UNITED STATES DEPARTMENT OF THE INTERIOR
BUREAU OF LAND MANAGEMENTNM OIL CONSERVATION
ARTESIA DISTRICT
JUN 20 2016
Carlsbad Field Office
OCD Artesia
RECEIVEDFORM APPROVED
OMB NO. 1004-0135
Expires: July 31, 2010SUNDRY NOTICES AND REPORTS ON WELLS
Do not use this form for proposals to drill or to re-enter an abandoned well. Use form 3160-3 (APD) for such proposals.

SUBMIT IN TRIPLICATE - Other instructions on reverse side.		5. Lease Serial No. NMNM0471842
1. Type of Well <input type="checkbox"/> Oil Well <input checked="" type="checkbox"/> Gas Well <input type="checkbox"/> Other		6. If Indian, Name or Tribe Name
2. Name of Operator YATES PETROLEUM CORPORATION		7. If Unit or CA/Agreement, Name and/or No.
Contact: LAURA WATTS E-Mail: laura@yatespetroleum.com		8. Well Name and No. FEDERAL CZ 1
3a. Address 105 SOUTH FOURTH STREET ARTESIA, NM 88210	3b. Phone No. (include area code) Ph: 575-748-4272 Fx: 575-748-4585	9. API Well No. 30-015-21058-00-D1
4. Location of Well (Footage, Sec., T., R., M., or Survey Description) Sec 8 T18S R25E NWNE 660FNL 1980FEL		10. Field and Pool, or Exploratory RICHARD KNOB
		11. County or Parish, and State EDDY COUNTY, NM

Yates Petroleum Corporation plans

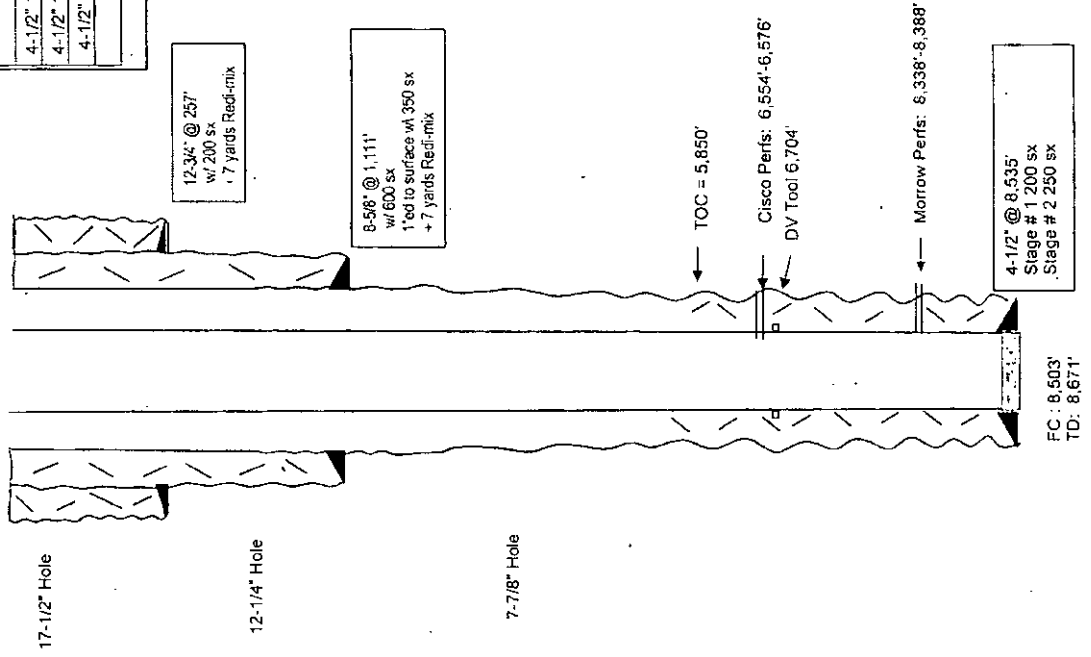
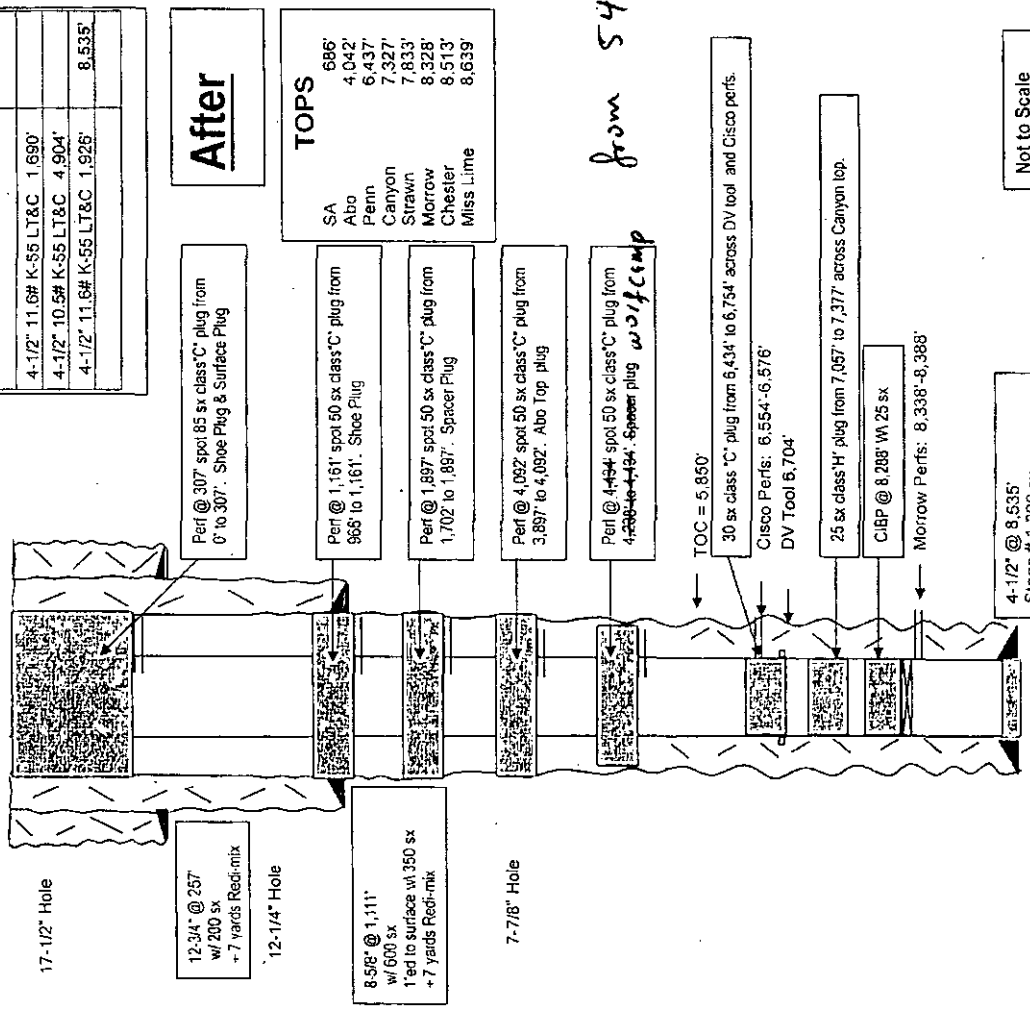
S215

Top of Wolfcamp plug

** BLM REVISED ** BLM REVISED ** BLM REVISED ** BLM REVISED ** BLM REVISED **

from 5410-5215'
